University of South Carolina
Longstreet Theatre Shutter Replacement

State Project Number: H27-6100-F

February 20, 2015

ADDENDUM NO. 2

USC PROJECT # CP00366430
STATE PROJECT # H27-6100
PROJECT NUMBER **14066**
SHEET NUMBER **A401**
SHEET NAME **ELEVATIONS**
DATE **01/09/15**

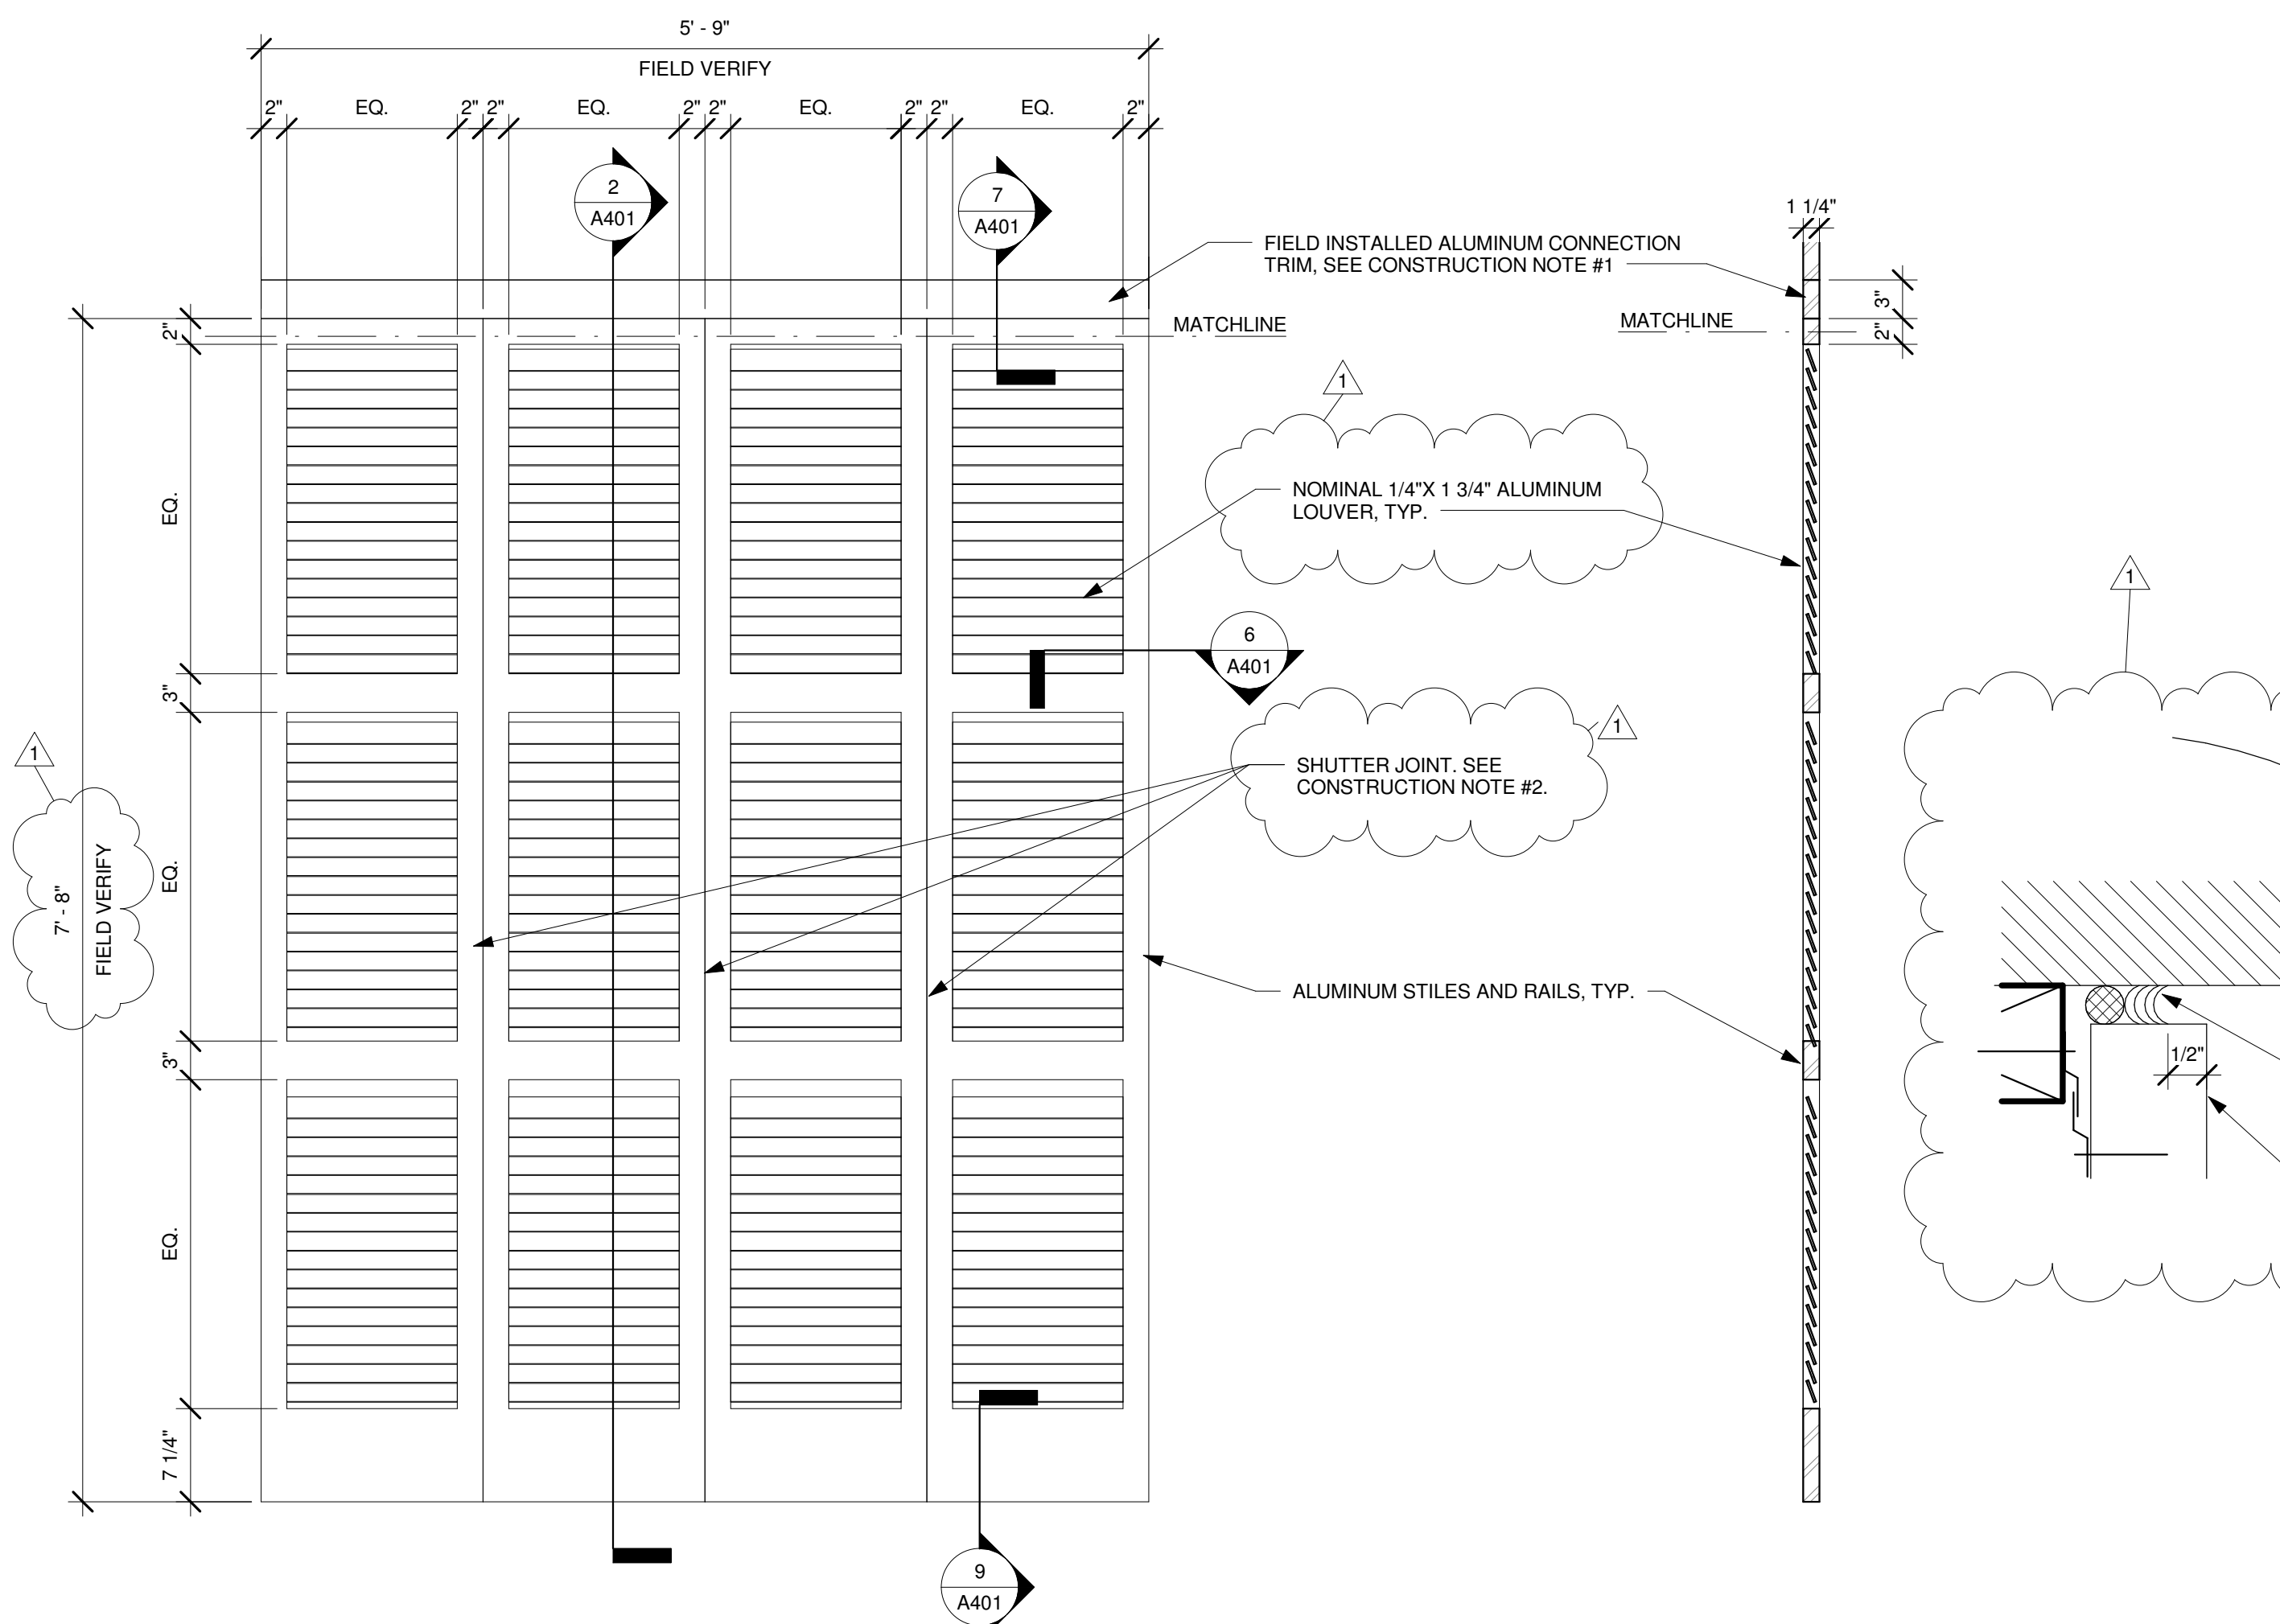
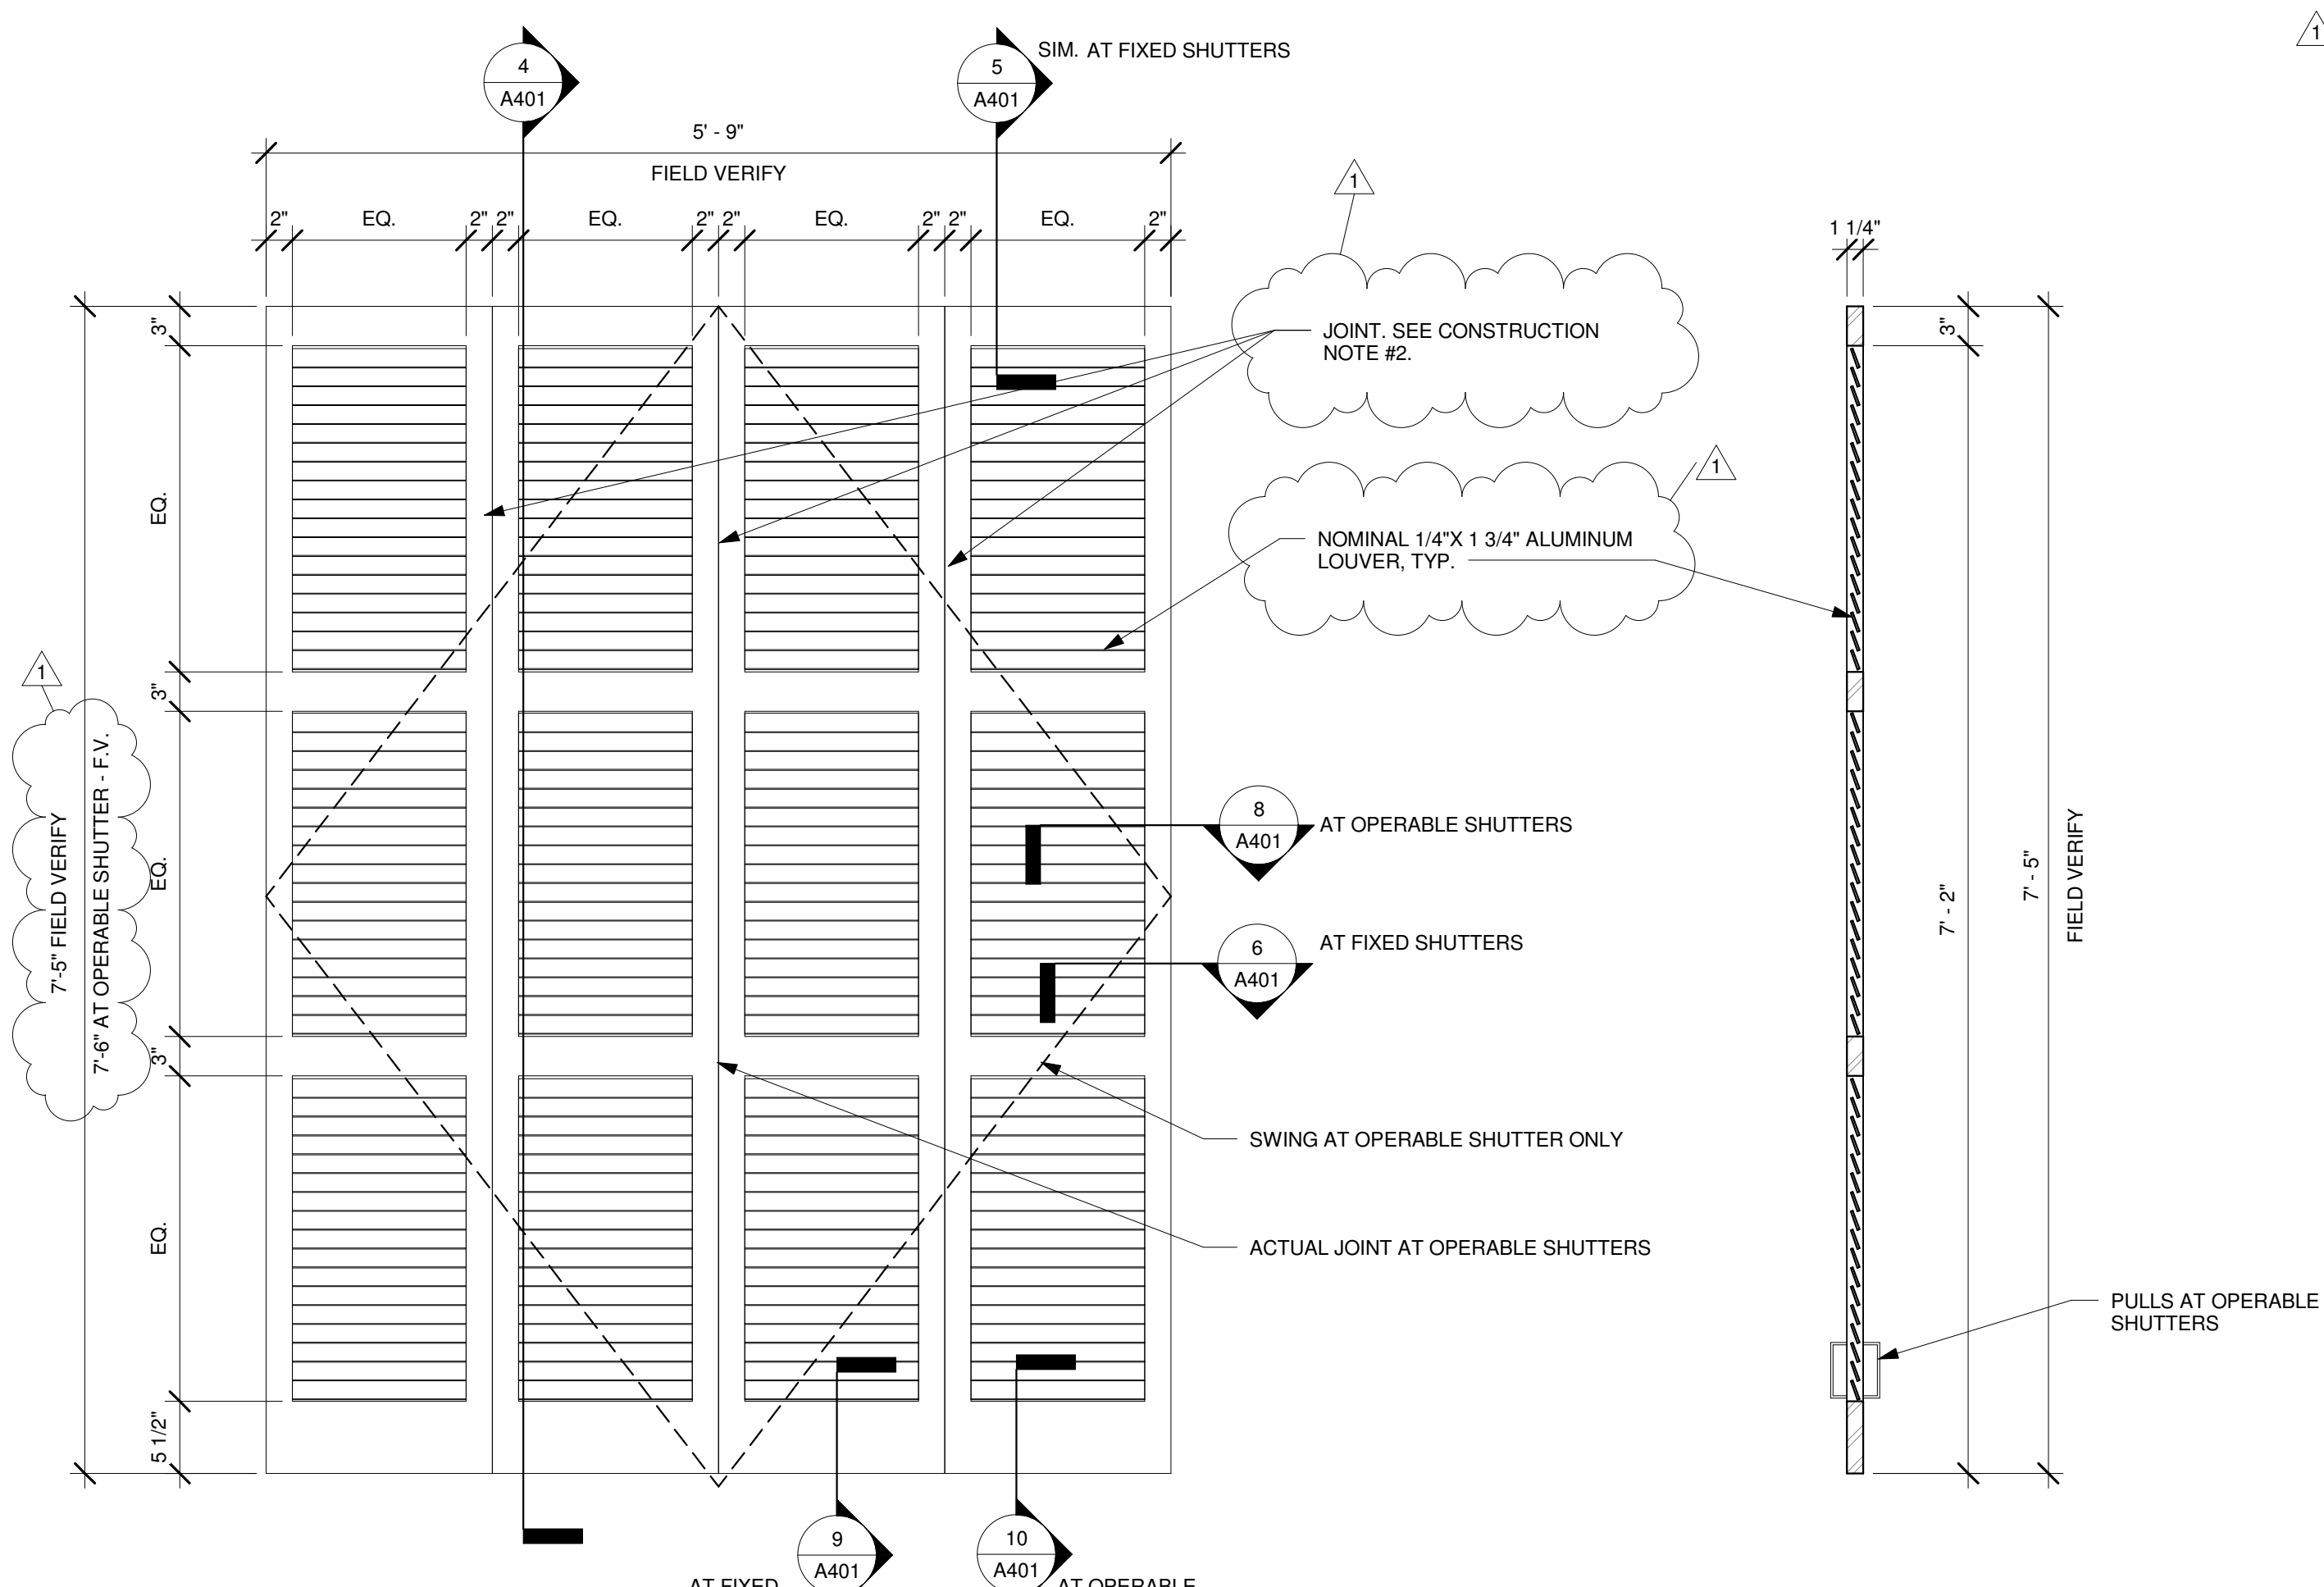
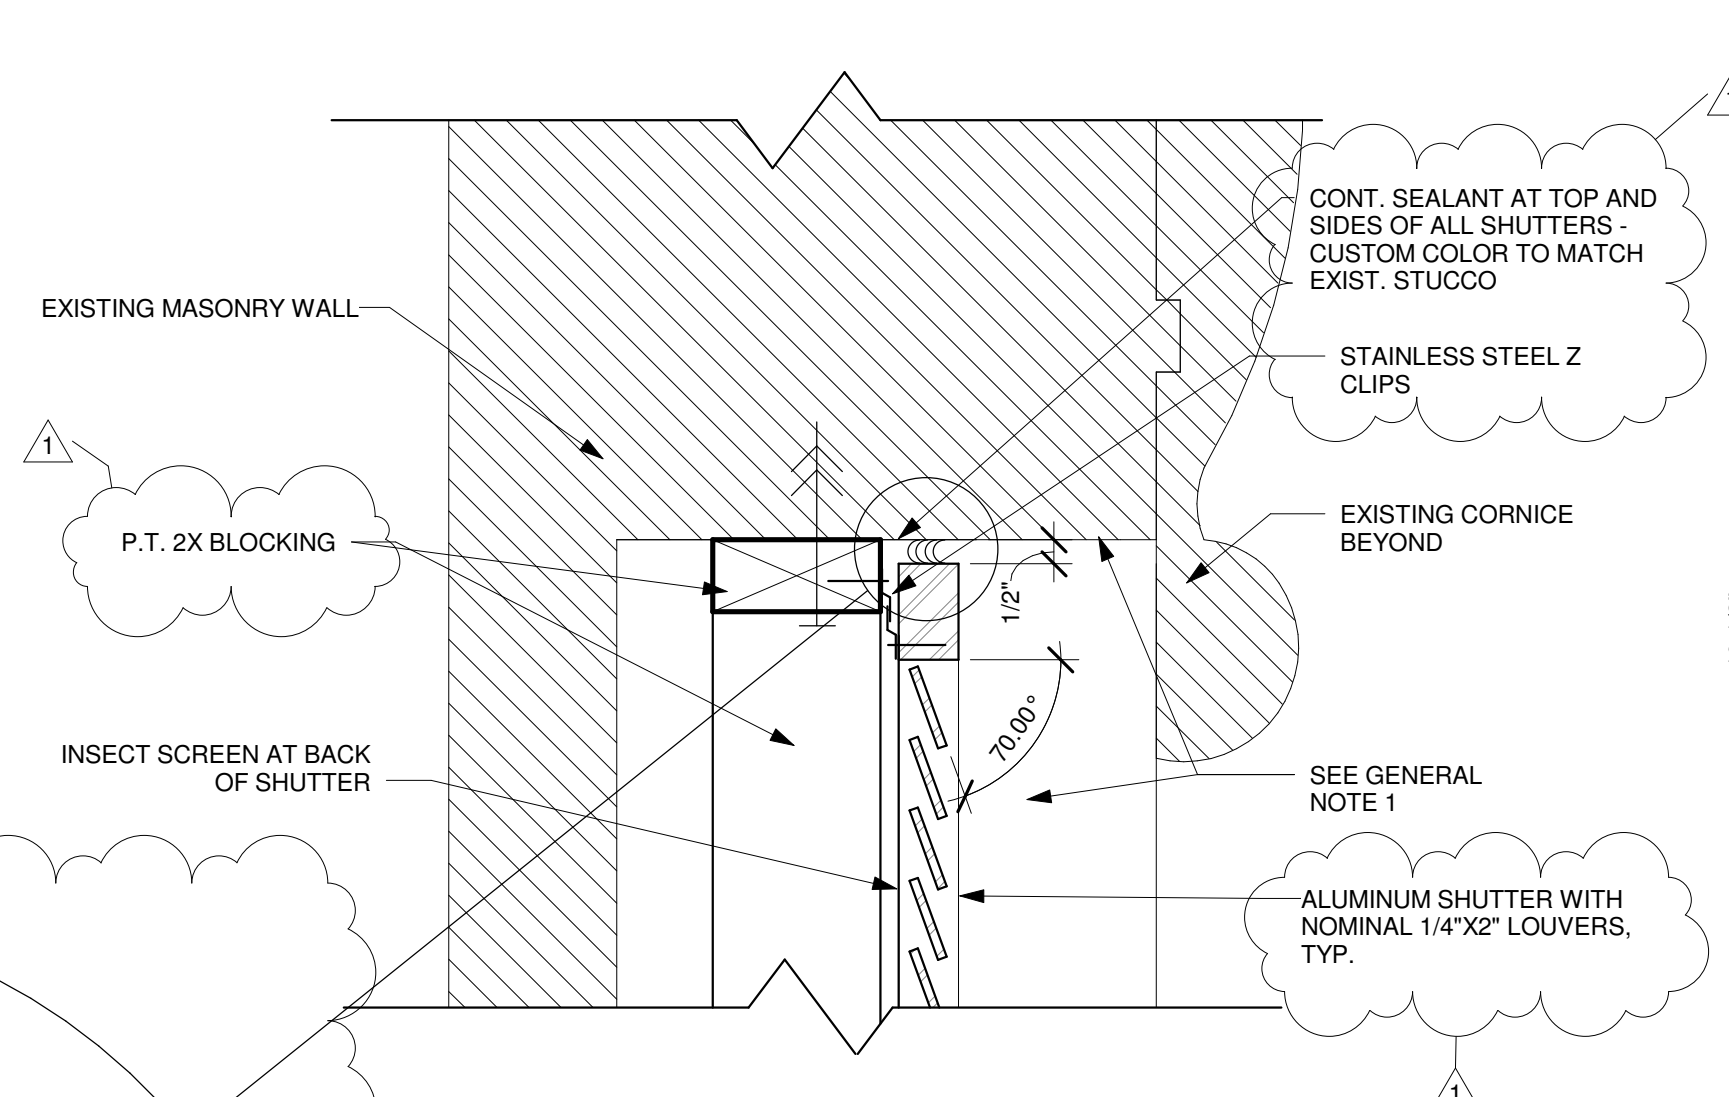
0. Question: Shutter 1,3,4 - 1.25 x 2 stile material is not an available size. Can 1.5 x 2 be substituted on stiles?
 1. **Answer: Yes**
1. Question: Shutter 1,3,4 - 1.25 x 3 rail material is not an available size. Can 1.5 x 3 be substituted?
 1. **Answer: Yes**
2. Question: Shutter 1,2,3,4 - 1.25 x 7.25 bottom rail is not an available size. Can 1.5 x 6 be substituted?
 1. **Answer: Yes**
3. Question: Shutter 2 - 1.25 x 5.5 mid rail is not an available size. Can 1.5 x 6 be substituted?
 1. **Answer: Yes**
4. Question: Shutter 2 - 1.25 x 3.25 stiles are not an available size. Can 1.5 x 3 be substituted?
 1. **Answer: Yes**

5. Question: Shutter 2 - 1.25 x 3.5 crown rail is not an available size. Can 1.5 x 3 be substituted?
1. Answer: Yes
6. Question: Shutter 2 - Can this be made as a three separate panels? Mating stiles could be 1.5 x 1.5 to yield 3" when ganged together.

1. Answer: Yes
7. Question: Drawings call for insect screen at back of shutter. Section 107113.13 EXTERIOR ALUMINUM SHUTTERS 2.3 Materials calls for a backing panel with the same finish as the shutter. Specify what the backing panel should be: solid or bug screen.

1. Answer: See changes to specification section 107113.13 in addendum 2.
8. Question: Please stipulate all joints that are to receive caulking/sealant.
1. Answer: Perimeter joints around the shutters are to receive sealant.
